ORIGINATION FORM

Proposed Revisions to a Standard Plans Index
(Please provide all information — Incomplete forms will be returned)

Index Number: 455-114

Index Title: 14" CFRP & SS Prestressed Concrete Piles

SECTION A-A

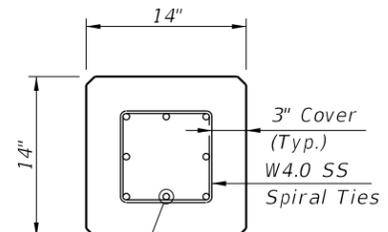
Added 0.6" HSSS strand

12 ~ 1/2" Ø, HSSS at 23 kips
 8 ~ 0.6" Ø, HSSS at 35 kips
